Access Compliance Report Public Rights-of-Way (Pedestrian Signals)

Main Street: **ANTONIO_PKWY** Cross Street: **WINDMILL_AVE** Location: **E**

ADA ID: **SGRK211029141718** Signal Type: **One Push Button-APS** Overall Compliance: **No** Severity Scores: **BTN 1: 25** **BTN 2: N/A** **No BTN: N/A**

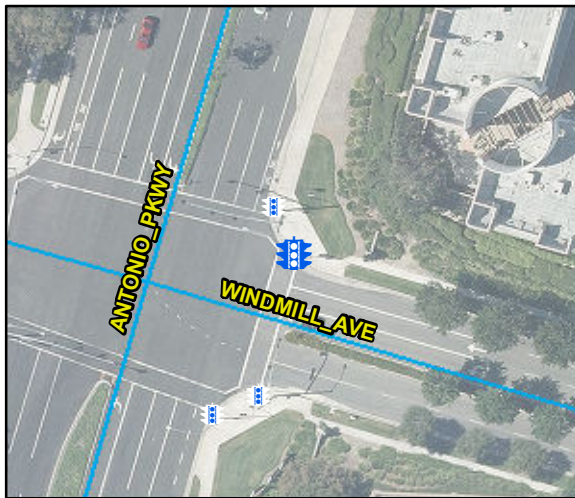
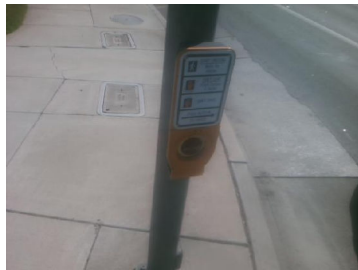
Possible Solutions: Remove and Replace Clear Space.

OC Std/PROW: R404.2, R404.3
